Waikato District Council
Attention: Milan Covic
Milan.Covic@waidc.govt.nz

17_147

68-72 GREAT SOUTH ROAD, POKENO – TRANSPORT PEER REVIEW ADDENDUM

Figure 1: Pokeno Road Signalised Intersection Schematic Drawings (WSP, 9 October 2020) with Gull Site Layout Overlay (Technitrades Architecture, 13 November 2020) (Not to scale)

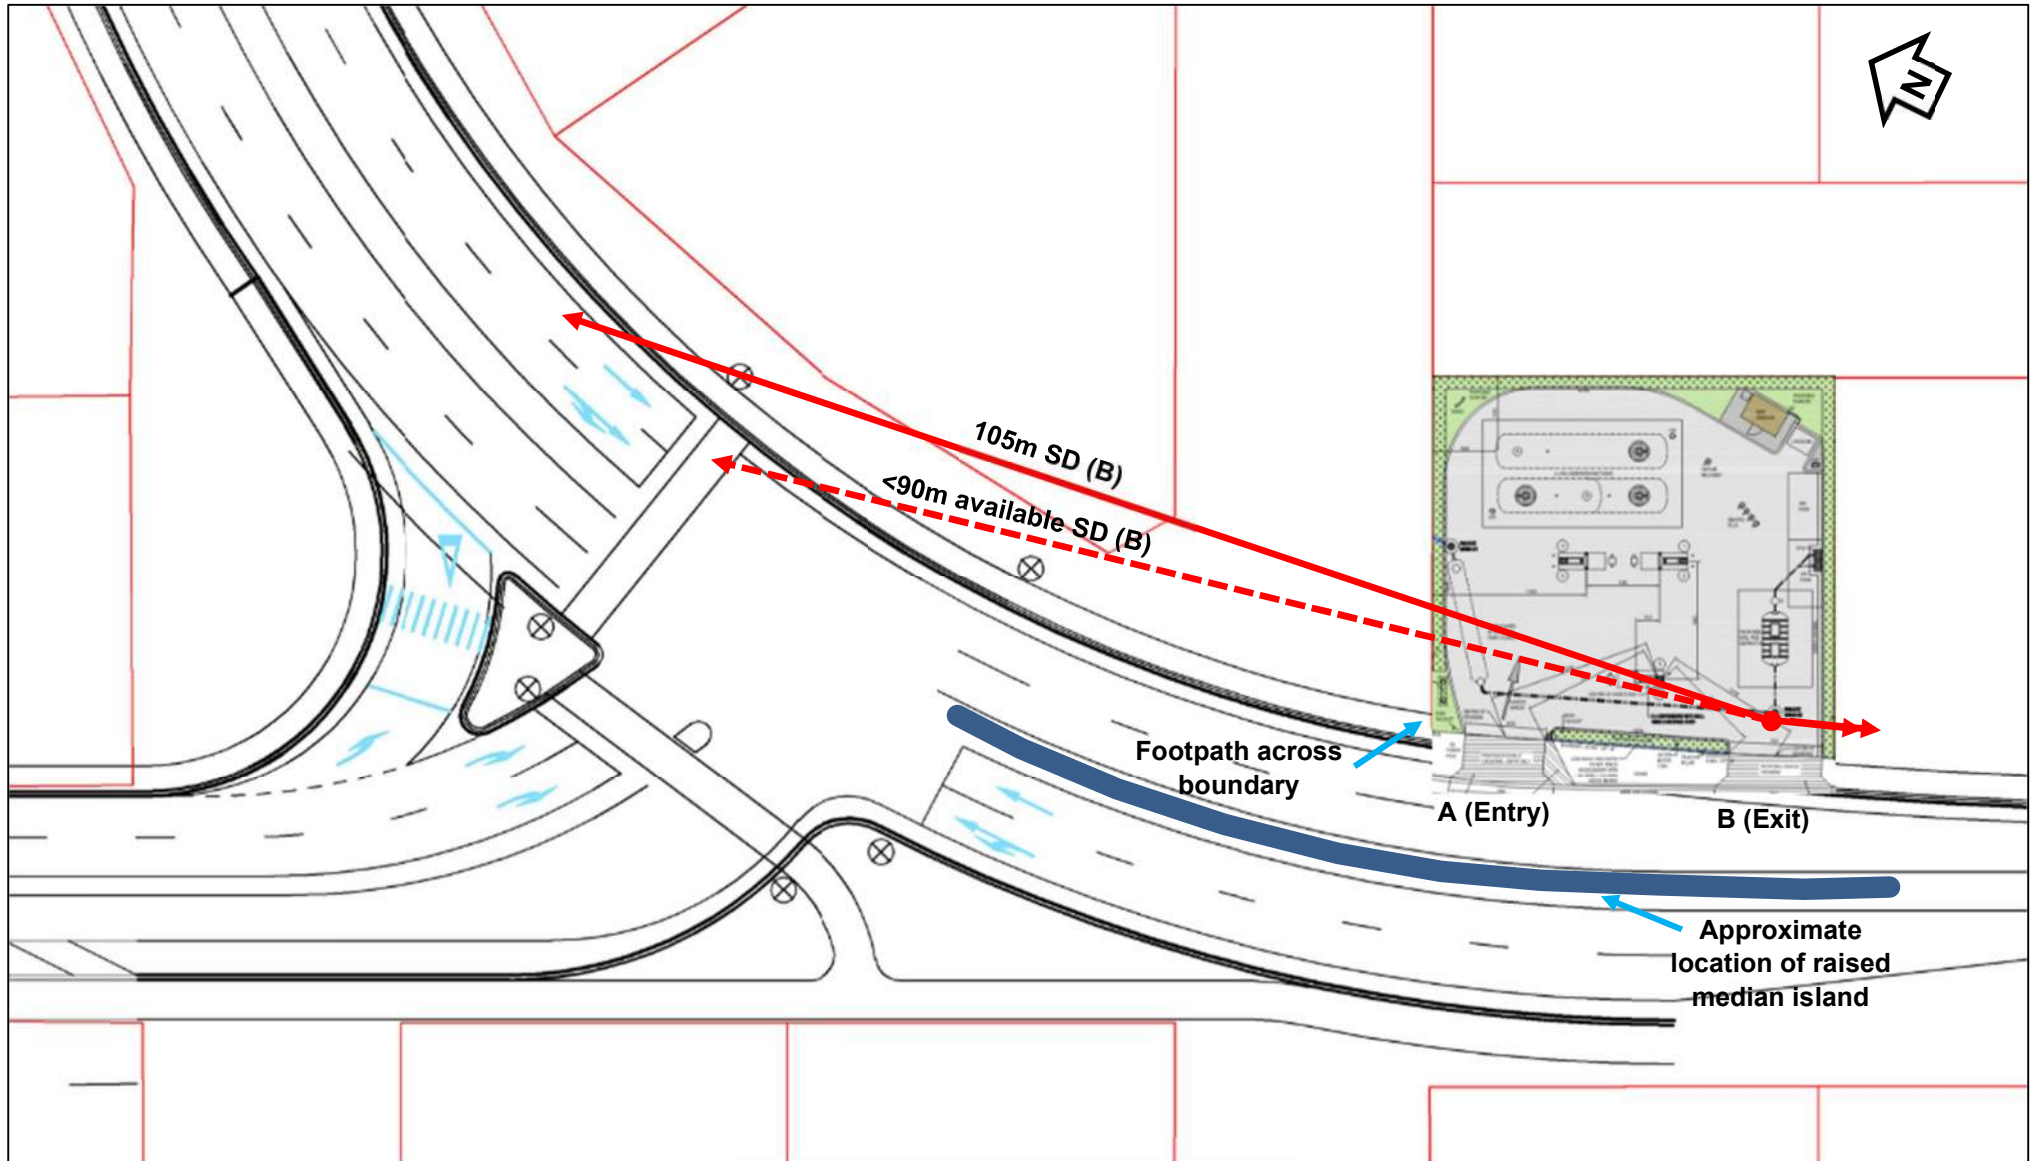
Figure 1 shows the approximate driver eye position and extent of the required 105m sight distance to the north (right) from crossing B (Exit).

As shown, the driver's line of sight passes across the north/Church Street boundary of the site (approximately 14-15m back from the frontage with Great South Road) and the adjacent property at 80 Great South Road to a greater extent than previously identified.

Whilst the changed driver eye position maintains SSD of 73m, there appears to be greater reduction in sight distance to the north. We estimate the available sight distance would be less than 90m. For a more conclusive assessment of sight distance and visibility requirements, we suggest the Applicant provide updated site plans that include the WSP design for the signalised intersection.

The effect of a shortfall in sight distance of 15m or more is an increase in likelihood of increased severity of a crash.

Figure 2: Fuel Tanker Swept Path for Right-Turn Entry, Right-Turn Exit (TIA)

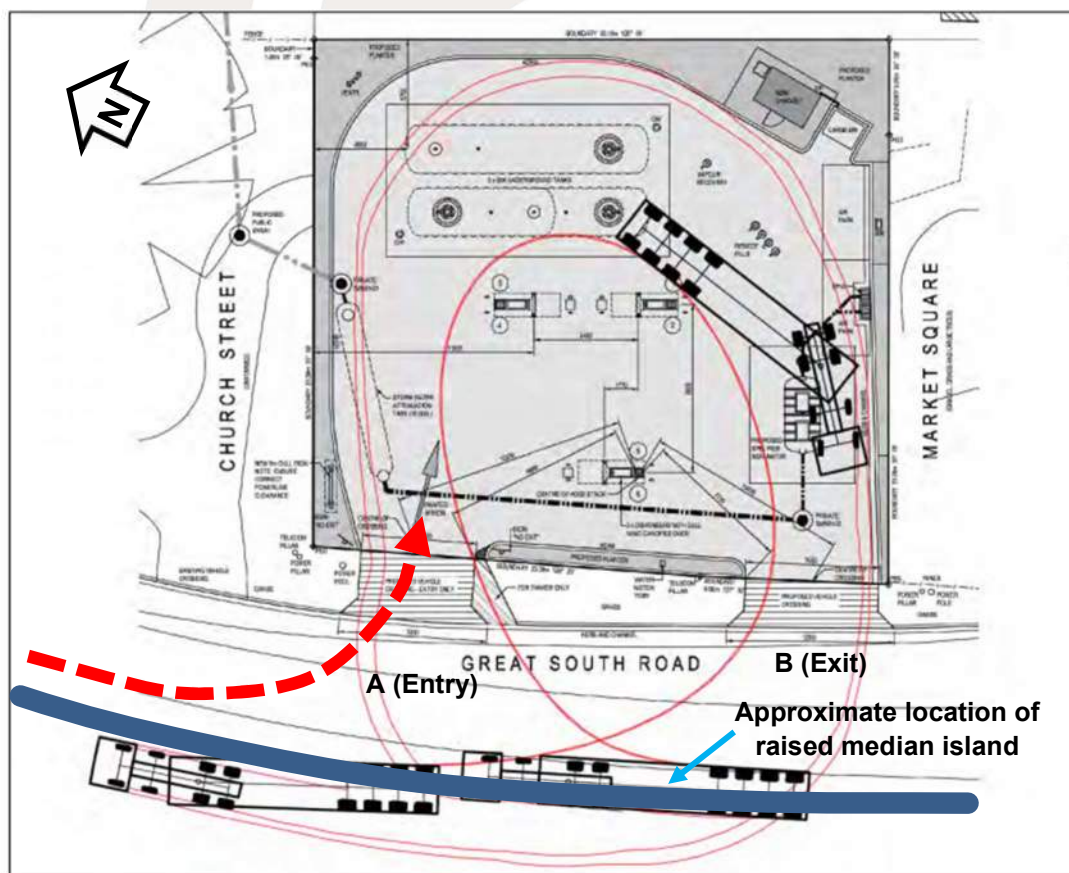
We consider it unlikely that a fuel delivery tanker will be able to turn left into the site (from the north) without occupying both southbound movement lanes and potentially impacting with the raised median island. Crossing A will require redesign.

Figure 3: Fuel Tanker Swept Path for Right-Turn Entry, Left-Turn Exit (979-200716Dwg.PDF)

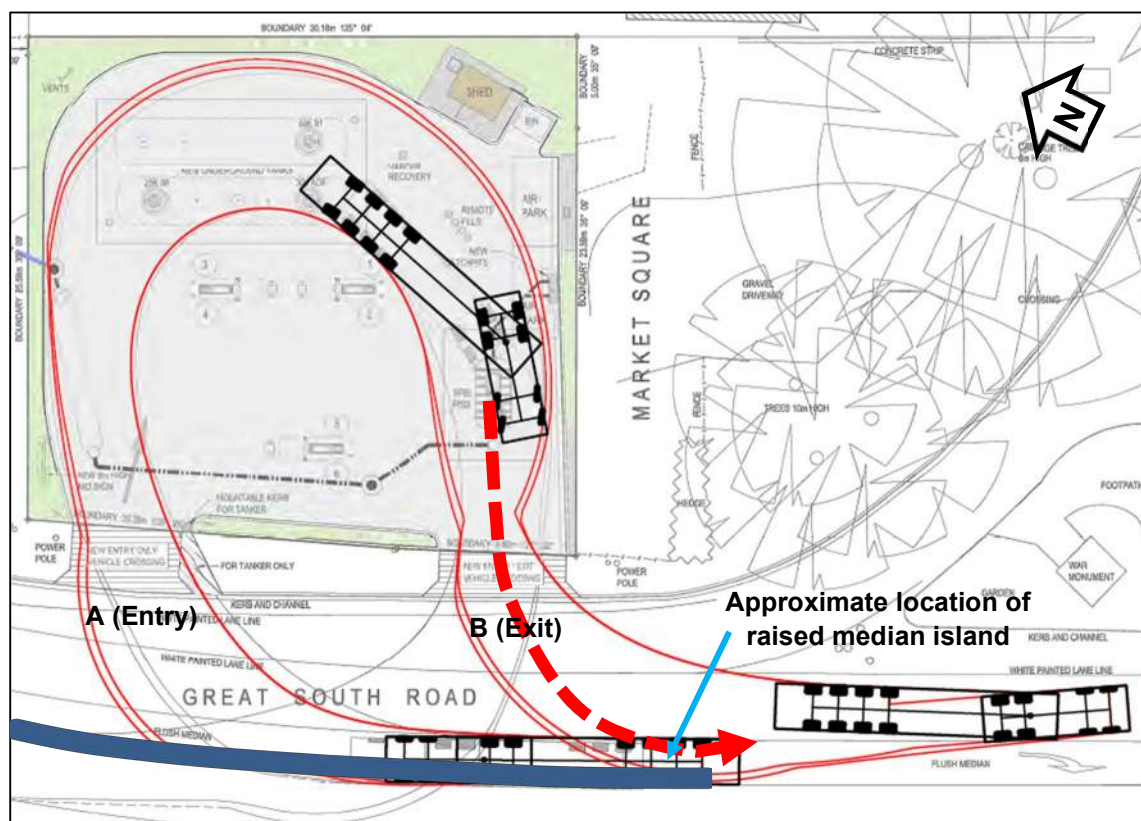
Our peer review commented in Section 4.6 On-site Manoeuvring, “the tanker can turn left to exit the site (as shown in Figure [3]) if the flush median space is used.” However, if there is a raised median island, we consider it unlikely that a fuel delivery tanker will be able to turn left out of the site (towards the south) without impacting the island.

If a raised median island is constructed on Great South Road, it is unlikely that a fuel delivery tanker would be able to access the site safely, without redesign of the vehicle crossings and on-site manoeuvring space.

Figure 4: Footpath Pinch Point (WSP, 9 October 2020)

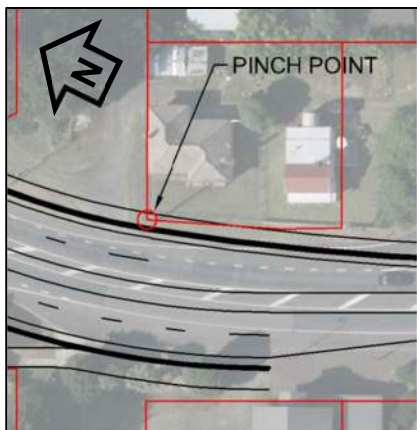
The WSP Intersection Schematic Drawings show the proposed intersection improvements will include widening of Great South Road in front of the proposed site. We note that a “pinch point” is identified on the WSP Intersection Schematic Drawings as shown in the figure at left.

The 2m wide footpath encroaches over the property boundary of the proposed site.

The proposed intersection design will require revision to avoid this pinch point, or acquisition of the land necessary to achieve the required berm and footpath widths.

Figure 5: Updated site plan (Technitrades Architecture, 13 November 2020)

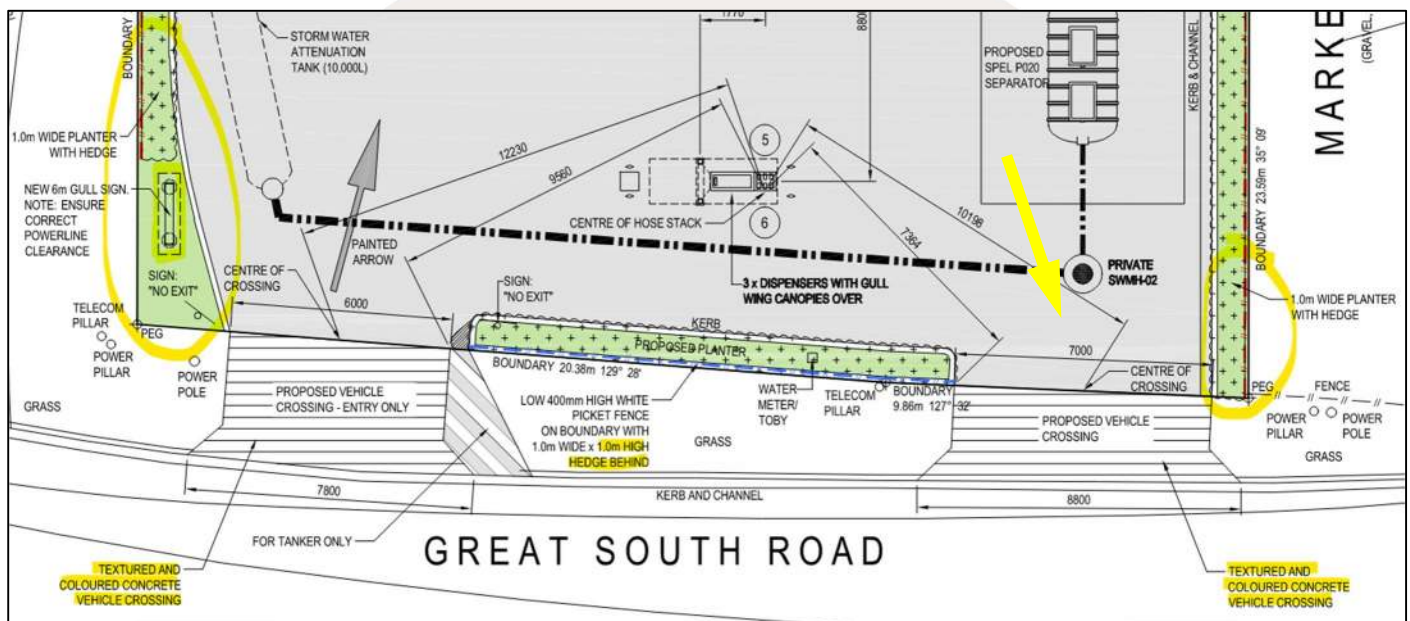
We note the updated site plan shows 1m high hedging along the frontage with Great South Road (refer Figure 5). This is inconsistent with the agreed 600mm height limit for vegetation in this area.

The updated site plan shows the gardens on the south/Market Square boundary extending to the frontage with Great South Road which differs from the previous site plans. As discussed above in Section 2.1.2 Vehicle Crossing B, we note the proposed changes to the road alignment in front of the proposed site may result in the driver eye position being located further back into the site. As such, sight distance to the south will be compromised if the landscaping along the south/Market Square boundary exceeds 600mm in height within 3-4m of Great South Road.

We note the updated site plan shows “Textured and coloured concrete vehicle crossings”.

As discussed above we suggest the Applicant provide updated site plans that include the WSP design for the signalised intersection.

Figure 6: Boffa Miskell Urban Design and Landscape Plan (4 November 2020)

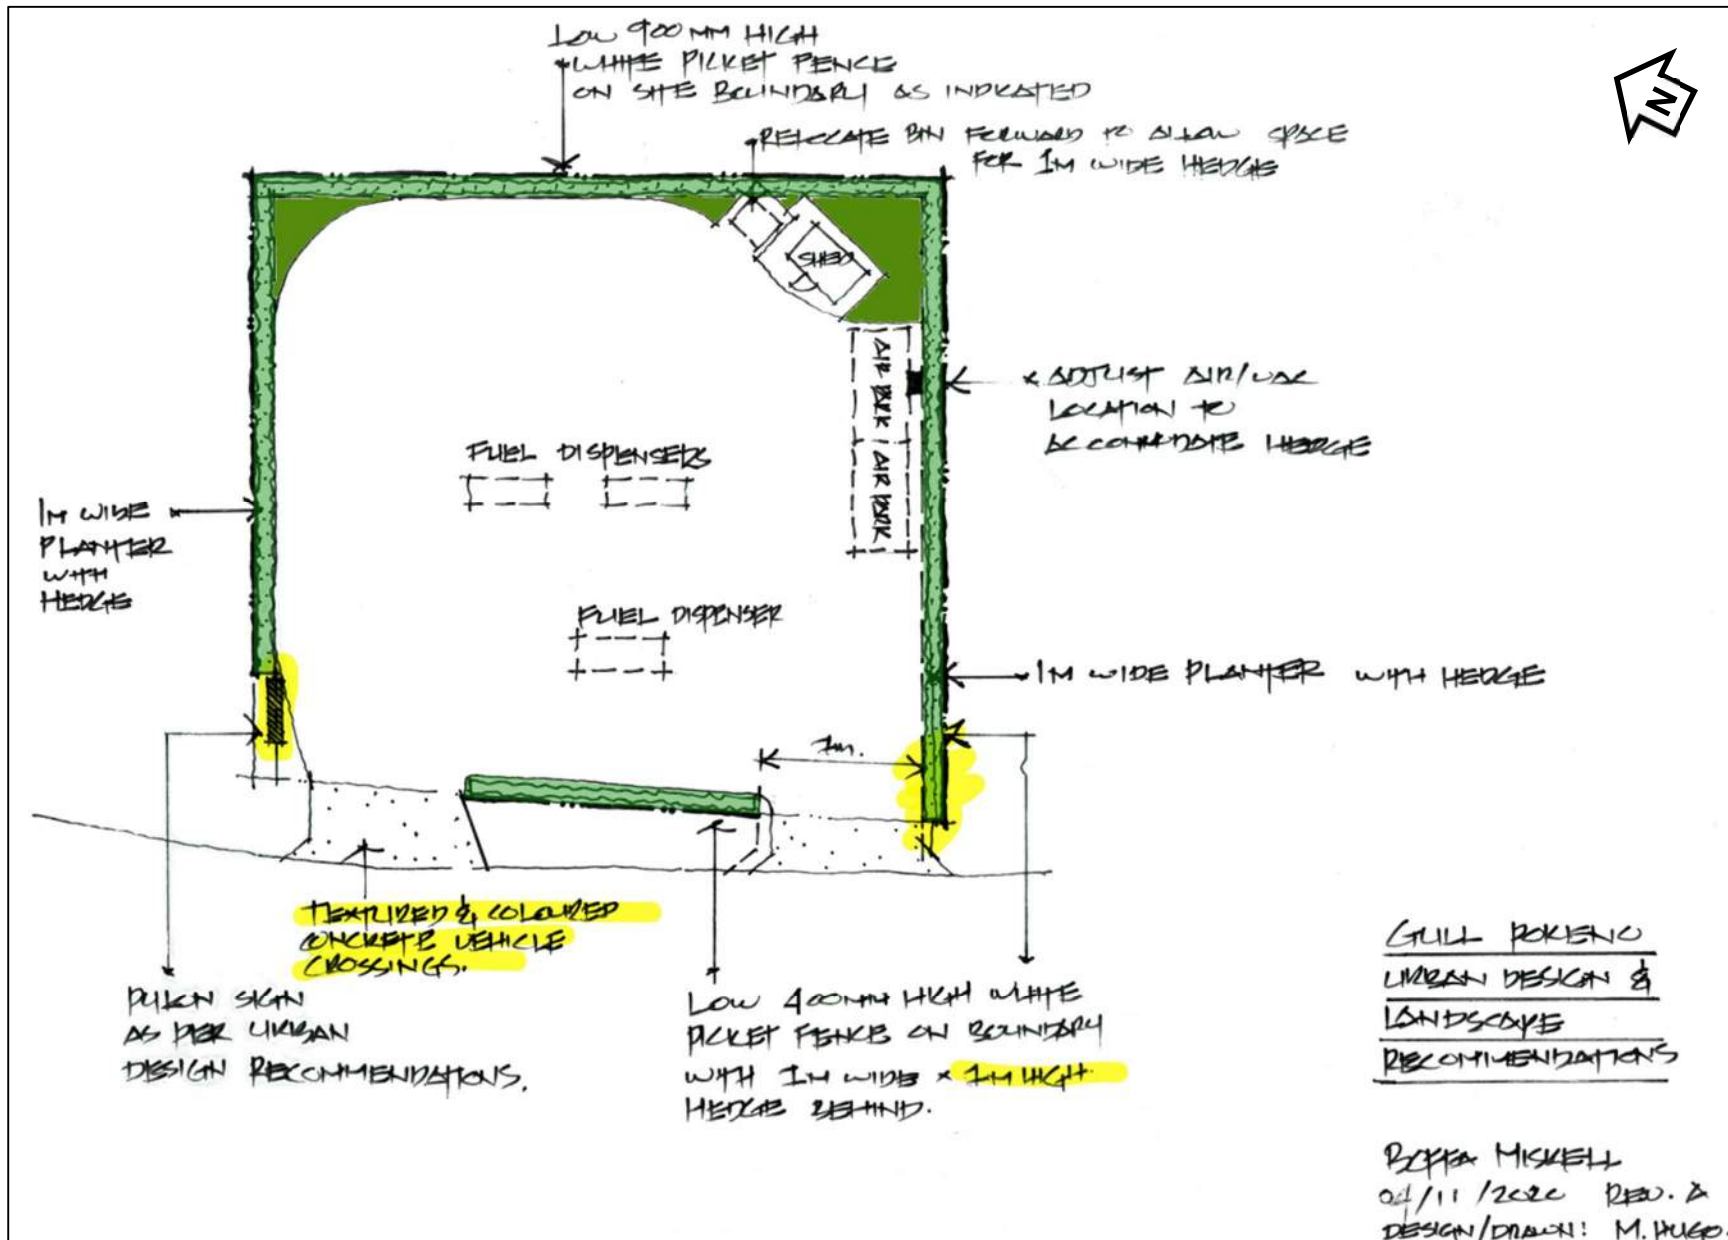
The updated Urban Design and Landscape Plan (Boffa Miskell, 4 November 2020) as shown in Figure 6 below includes the alterations requested in our peer review and discussed at the meeting of 9 October 2020. The changes shown on the Boffa Miskell plan have been incorporated into the updated site plans.

We note that the Boffa Miskell plan and updated site plan both show the sign within the 6m setback which is inconsistent with the required mitigation. Locating the sign further back into the site may encroach on the manoeuvring space required for fuel delivery tankers.

As suggested above, the applicant should provide vehicle tracking plans for the updated site layout.

Figure 7: Recommended Vehicle Crossing Treatment (Gray Matter Peer Review, Issue 1, July 2020)

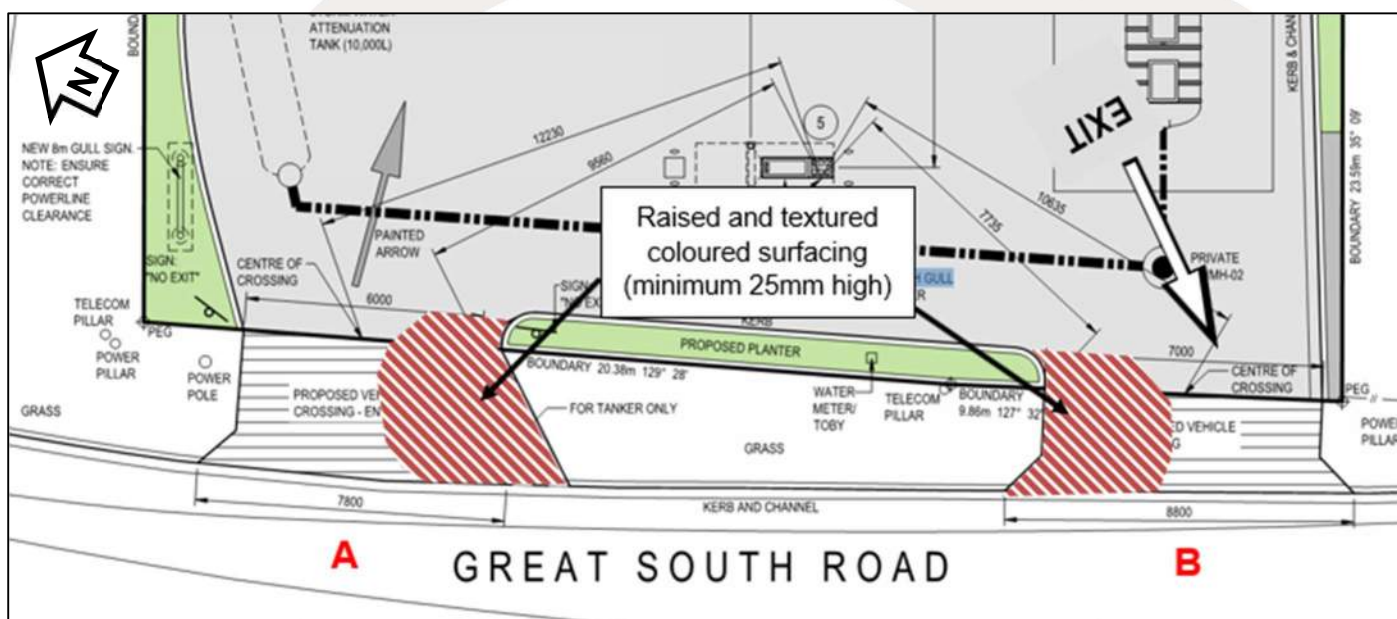
Our suggested mitigation (shown in Figure 7 below) sought to visually narrow the vehicle crossings to a single lane for entry and exit and discourage cars and light vehicles from using the additional width to enter at high speed or travel against the flow of traffic, whilst allowing heavy vehicles to track over the raised and textured areas.

In our peer review we stated that “*hatched marking alone would not alleviate our concerns.*” Similarly, textured, and coloured concrete across the full width of the vehicle crossing would not alleviate our concerns. The raised surfacing should be limited to the area beyond that required for manoeuvring by light vehicles.

Figure 4: Proposed layout of Pokeno Road/Great South Road Signalised Intersection (From Graham Block, Pokeno, Integrated Transport Assessment, Arrive 2017).

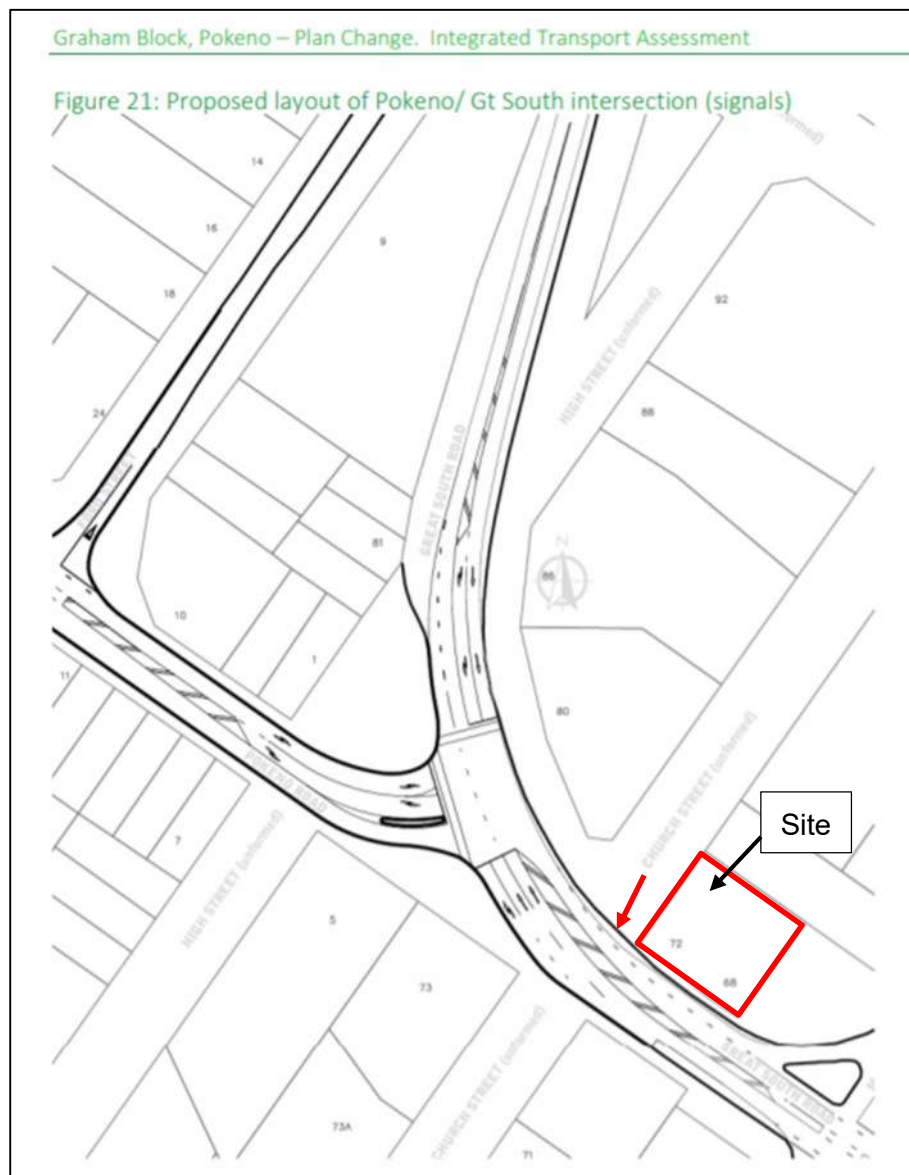
We note that the figure shows road widening where Great South Road intersects with the unformed section of Church Street (indicated by the red arrow). The potential loss of berm space may result in adverse safety effects for the proposed development at 72 Great South Road.
